Report: TAB Report
Function: Test, Adjust, & Balance
Date: 12/17/2025
Completed By: National TAB

12-08-25 WHATABURGER #1667 LARGO, FL

Project Issue Information

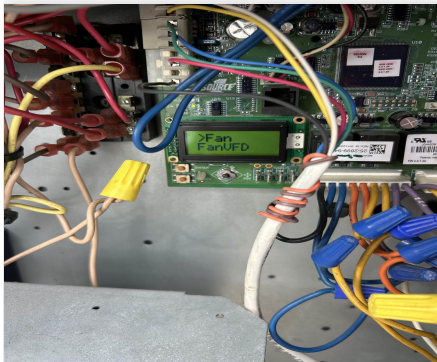
Issue Name : Economizers Not Operational
Description : All RTU economizers are not functional. For RTUs 1 and 2, the damper does not respond to setpoint changes. RTUs 3 and 4 do not have economizer setpoints enabled on the controller. All economizers must be functional to complete TAB.
Created By : National TAB **Assigned To :** National TAB - Will Turnbough
Status : Open
Priority : Urgent **Asset Tag :**
Originated Date : 12/08/2025 - Mark Johnson - National TAB

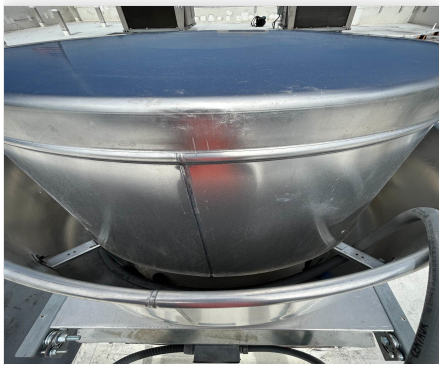
Issue Name : EFs 1, 2 - Conduit Placement
Description : The conduit for both hood exhaust fans is routed around the inside of the fan, with risk of damage from grease over time.
Created By : National TAB **Assigned To :** National TAB - Will Turnbough
Status : Open
Priority : High **Asset Tag :**
Originated Date : 12/12/2025 - Mark Johnson - National TAB

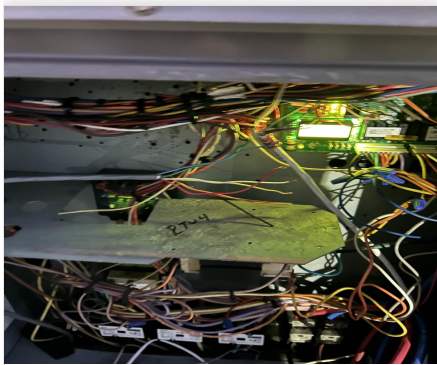
Issue Name : RTUs - Loose Wires
Description : All RTUs have loose sensor wires inside their controls cabinet. Recommend installation.
Created By : National TAB **Assigned To :** National TAB - Will Turnbough
Status : Open
Priority : High **Asset Tag :**
Originated Date : 12/12/2025 - Mark Johnson - National TAB
